SITE INSTRUCTION # 11

Project Name: Hampton Manor (25 Baker Hill Boulevard) - Stouffville

Project Number: 20140490

ROOF FRAMING PLAN
As indicated
S1-07

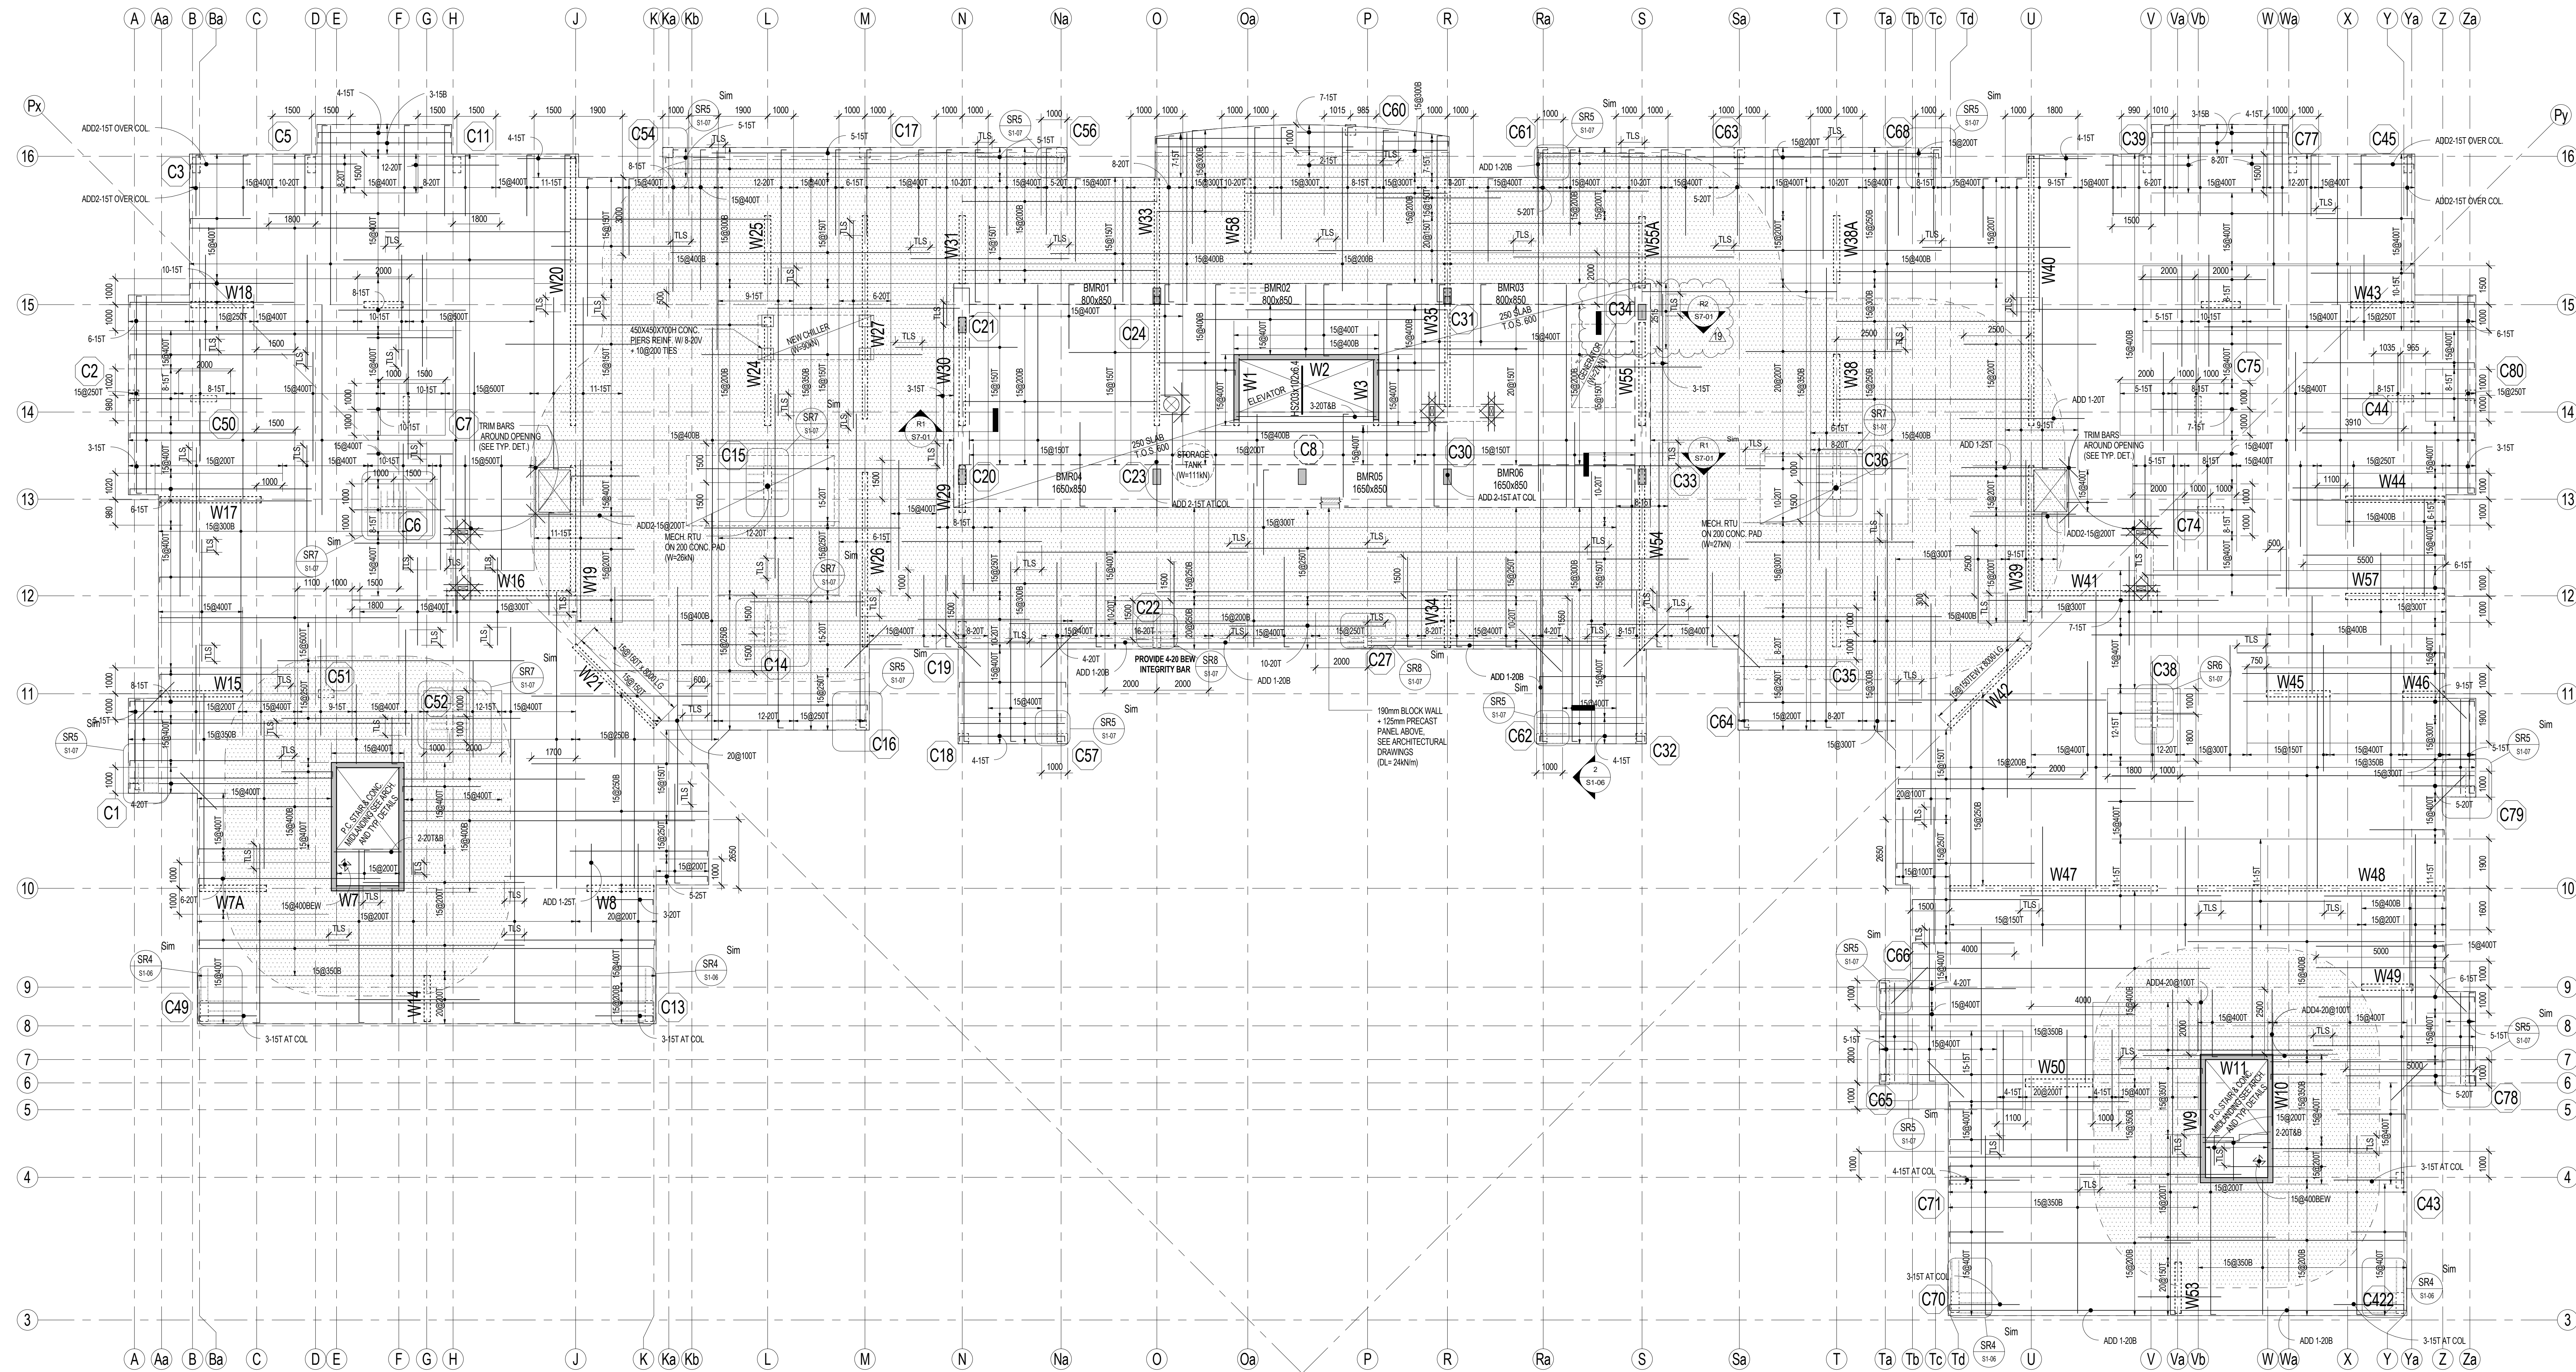
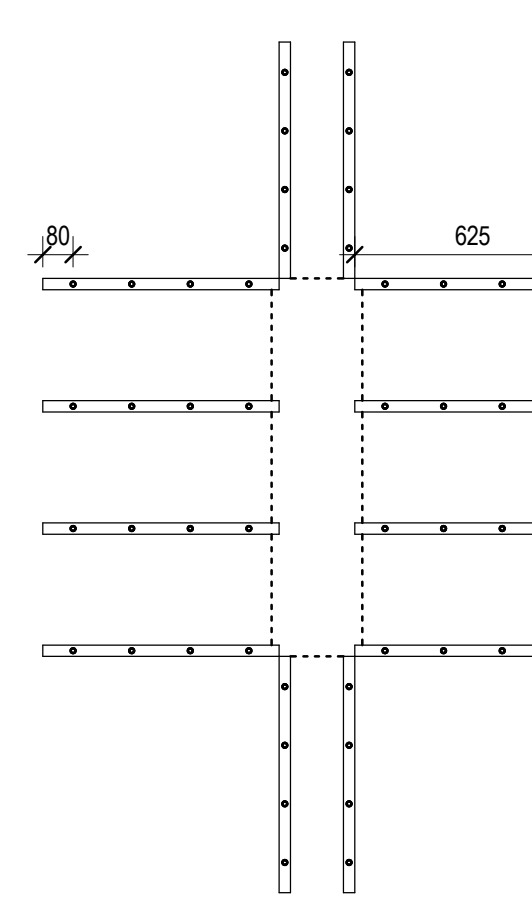
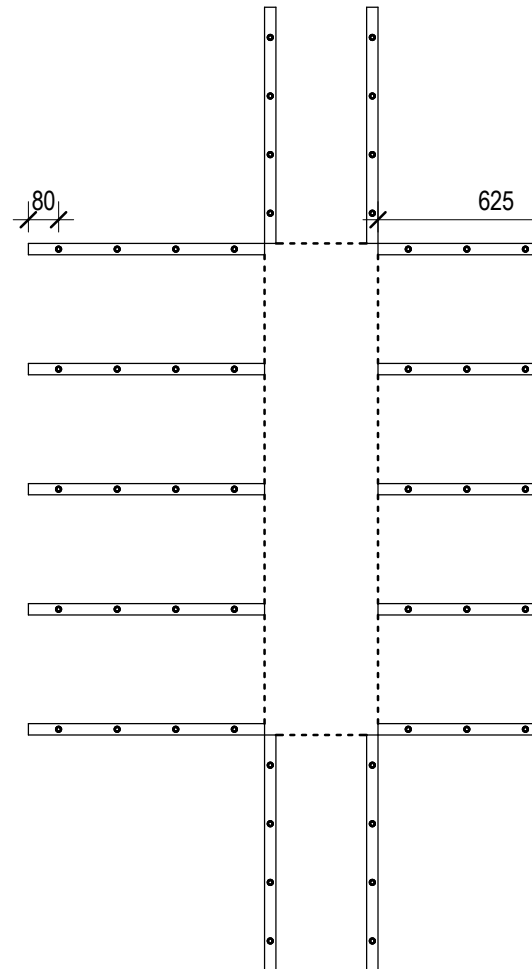
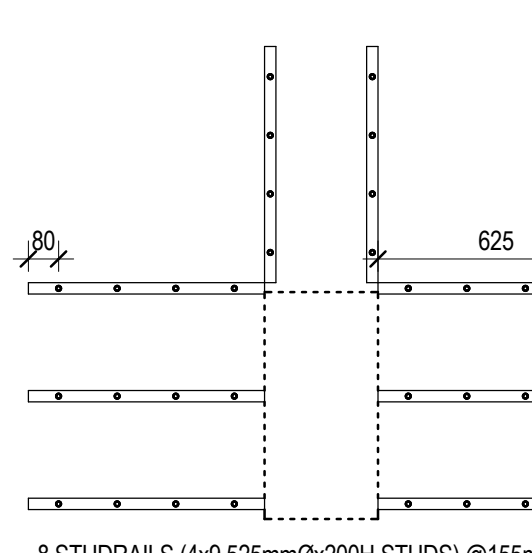
- .1 Revise location of Mechanical Penthouse column C34 by 500 mm to the West, and provided additional reinforcement as indicated.
